# METROPOLITAN GOVERNMENT OF NASHVILLE AND DAVIDSON COUNTY

## STAFF RECOMMENDATION 2818 Belcourt (514 32<sup>nd</sup> Avenue) February 20, 2013

**Application:** New construction-infill  
**District:** Hillsboro-West End Neighborhood Conservation Zoning Overlay  
**Council District:** 18  
**Map and Parcel Number:** 10406030700  
**Applicant:** Peggy Newman  
**Project Lead:** Robin Zeigler, robin.zeigler@nashville.gov

<p><b>Description of Project:</b> The applicant proposes to demolish the non-contributing building and construct a single-family, one and one-half story building on this corner lot at 32<sup>nd</sup> and Belcourt Avenue.</p> <p><b>Recommendation Summary:</b> Staff recommends a approval of the primary building and attached garage with the conditions that:</p> <ul style="list-style-type: none"> <li>• Staff provide final approval of window design, roof colors and materials for vehicular and pedestrian doors, trim, walkway, driveway and rear deck;</li> <li>• The front yard parking area be removed;</li> <li>• The staired windows on the front be smaller to be more in keeping with historic accent window;</li> <li>• The dormer have a second window or larger window to bette

**514 32nd**  
**FRONT**

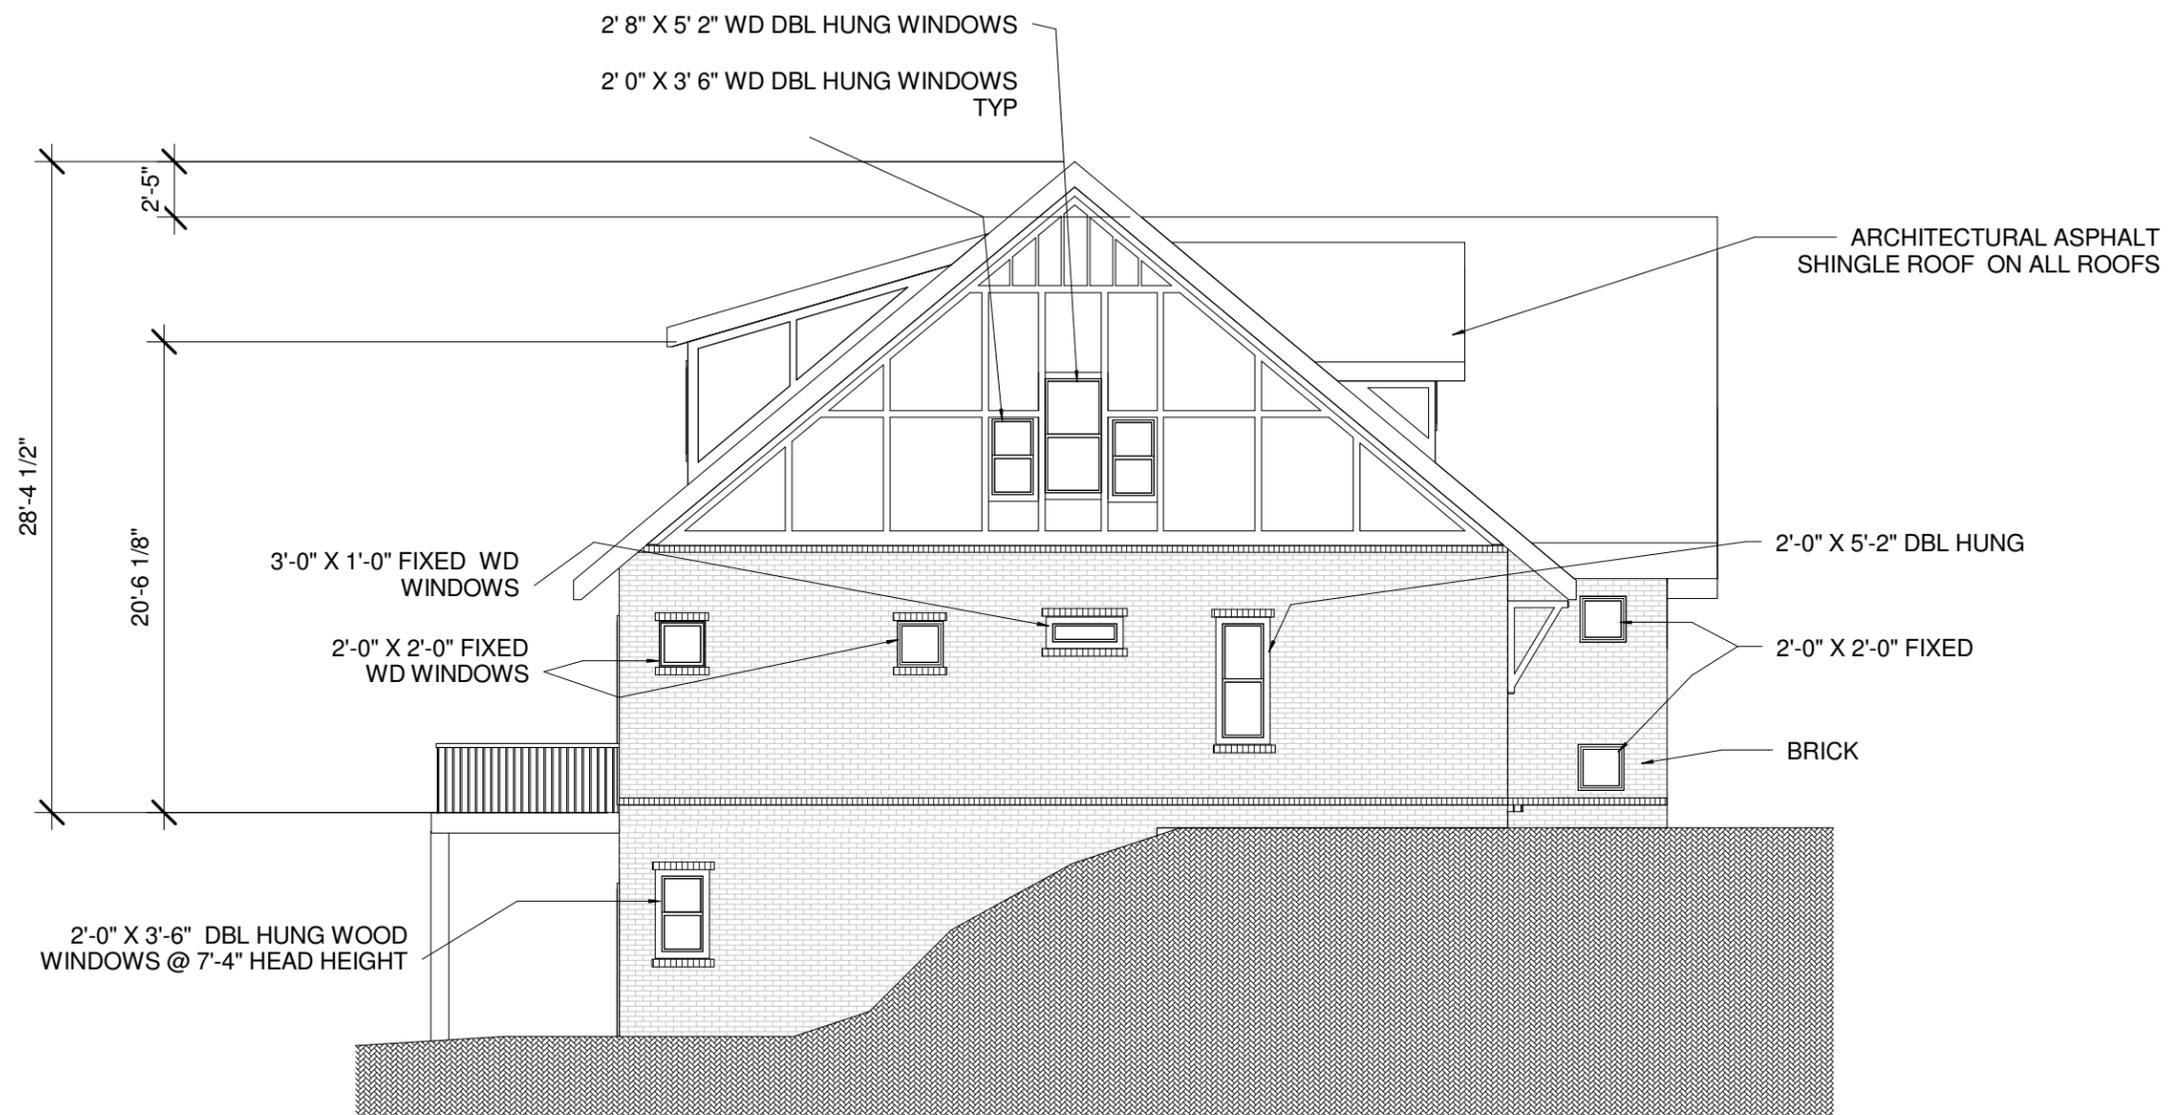
The proportions of the majority of windows is twice as tall as they are wide, as found in the district. Typically accent windows are smaller than the primary windows of the main façade, and second story windows are either the same size or shorter than ground floor windows. The three-staired windows on the main façade are accent windows that should be smaller than the tripartite windows on the right or the row of three windows to the left.

Generally the face of dormers are mostly window. Staff recommends increasing the size of the window in the gabled dormer or adding paired windows to come closer to historic examples. Mullions that are a minimum of four to six inches wide have typically been required on paired windows. The drawings note the mullions but do not show them. For clarity, Staff recommends a condition that the paired windows have a 4" mullion.

- Staff provide final approval of window design, roof colors and materials for vehicular and pedestrian doors, trim, walkway, driveway and rear deck;
- The front yard parking area be removed;
- The staired windows on the front be smaller to be more in keeping with historic accent window;
- The dormer have a second window or larger window to better fit the face of the dormer;

# SITE PLAN

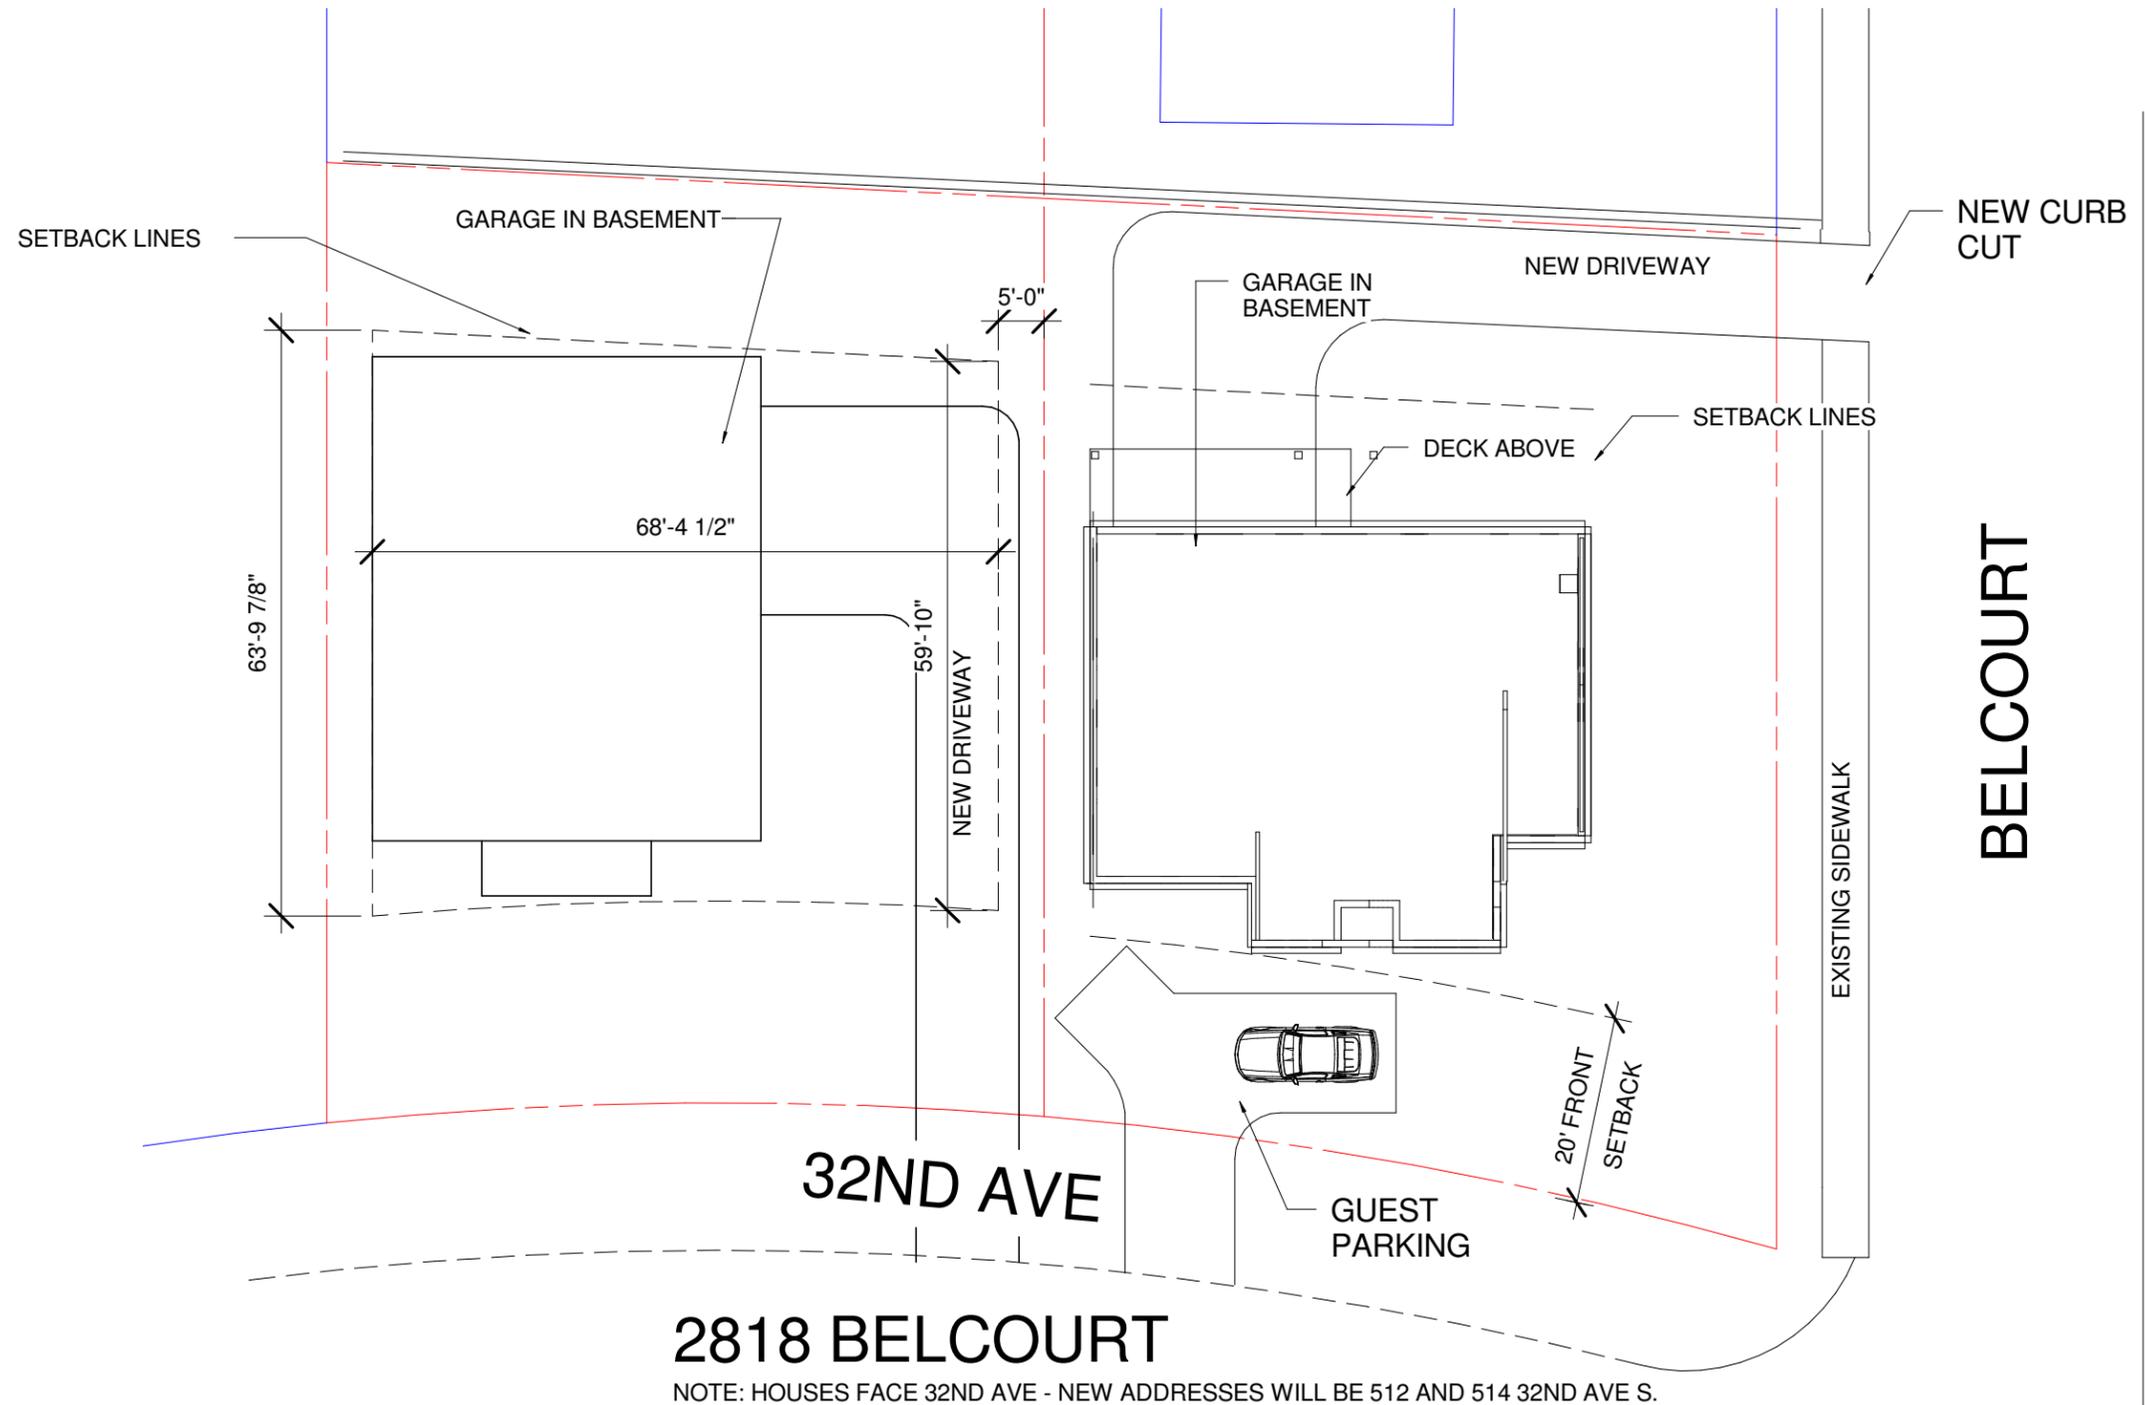
The front setbacks in the immediate vicinity vary greatly, again, mainly because the curve in the street. The homes across the street have deep setbacks of approximately fifty feet (50'). On the east side of the street, the setbacks are in the twenty foot (20') range. This house is proposed to be slightly forward of the new home proposed to the left and more in line with the home one door down. Staff finds this setback to be appropriate because of the slight curve in the street that.

The house sits to the left of the lot, as do some homes in the district. This location also allows for more greenspace on the Belcourt Avenue side of this corner lot. The project meets all bulk zoning requirements: left side setback five feet (5'), right side thirty feet (30') and rear approximately thirty feet (30').

The main entrance will connect to the street with a walkway. Typically, walkways lead straight from the front steps to the street or sidewalk; however this one leads to a front yard, parallel to the street, parking area. The Commission has only allowed for parking

in the front yard when the grade was too steep to accommodate a driveway and there was no alley access. In this case, there is no alley access but there is a single-lane driveway proposed to lead from Belcourt Avenue to an attached garage. Staff recommends removal of the front parking area. Typically, new curbcuts and driveways are inappropriate; however, this lot does not have alley access and driveways are a typical feature for surrounding lots. With this condition the project meets section II.B.f of the design guidelines.
